HUDSON BORGWARNER DG-200 Transmission Dipstick comparison

In 1953 the transmission provider to Hudson was unable to continue supplying Hydramatic transmission due to a factory fire. This occurred at a time when Hudson was in the midst of manufacturing the 1954 Models. With a dwindling supply of in-stock transmissions, Hudson developed the engineering to change the transmission to the Detroit General or Borg Warner automatic transmission. The DG-200 was a variant of the transmission found in other makes including Jaguar and Studebaker. The transmission was different than that used by Hudson in its Stock cars and was not favored by buyers and later HET owners. As the production of the Hudsons with the DG200 matured, field use problem calls were collected. One of those calls indicated that shifting and drivability issues were being experienced. factory engineering and field mechanics soon determined the Dipstick supplied with the early use units did not properly indicate the proper fluid fill level.

Figure 1

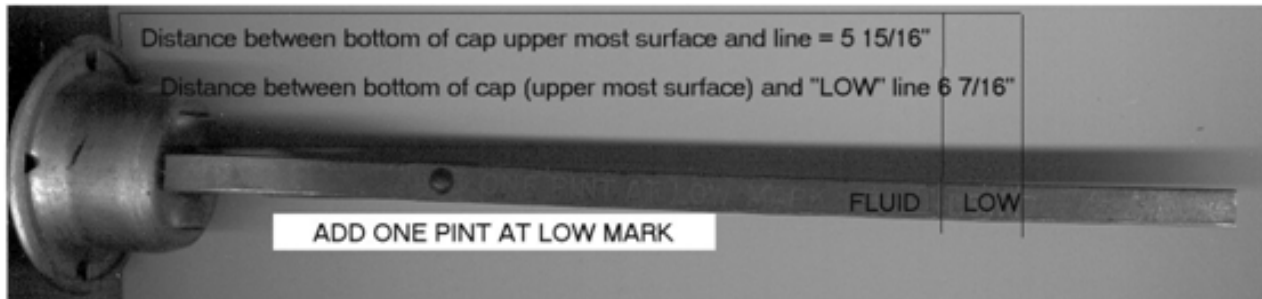
Hudson determined the marking on the dipstick was wrong for their application and issued a field bulletin to dealers and service centers. That information is captured in the picture shown at figure 1.

Figure2

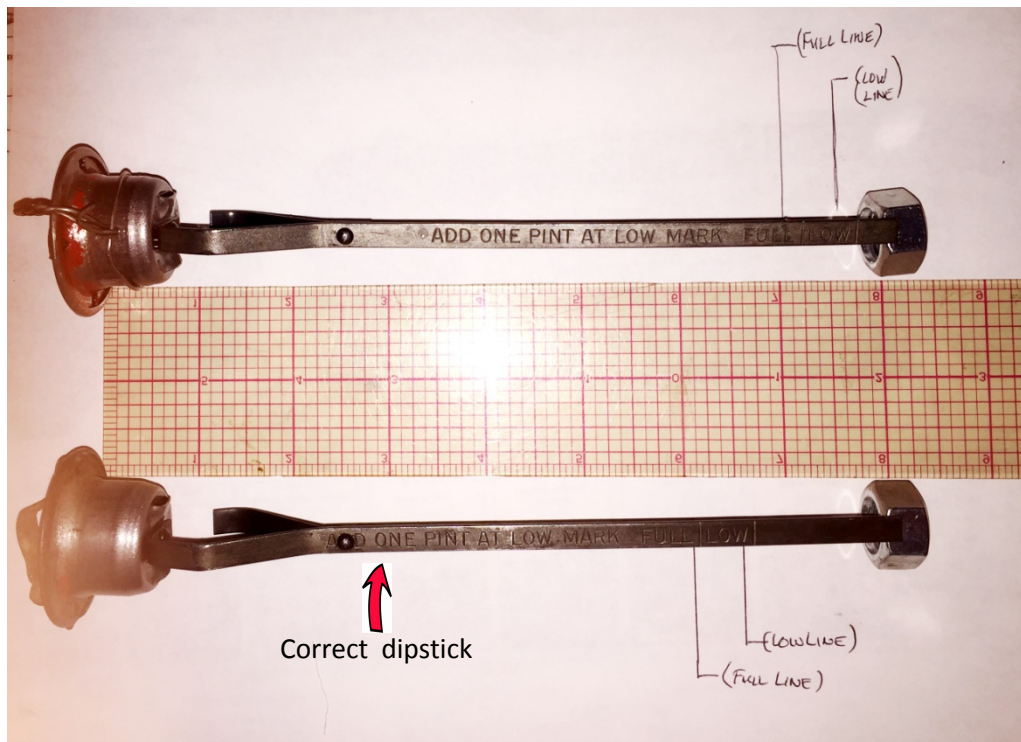
The difference between the correct and incorrect making is shown in figure 2.

The dipsticks shown in figure 2 represent the difference in the fluid levels that the transmissions would have to meet the markings. When the incorrectly marked dipstick was removed from a 1954 Hudson Super Wasp equipped with the DG-200; it was replaced with the properly marked dipstick shown in the picture. The transmission fluid service at the time of the dipstick swap was correct for the original dipstick. Bringing the fluid service to the proper levels indicted by the properly marked dipstick required 1.25 quarts of additional fluid.
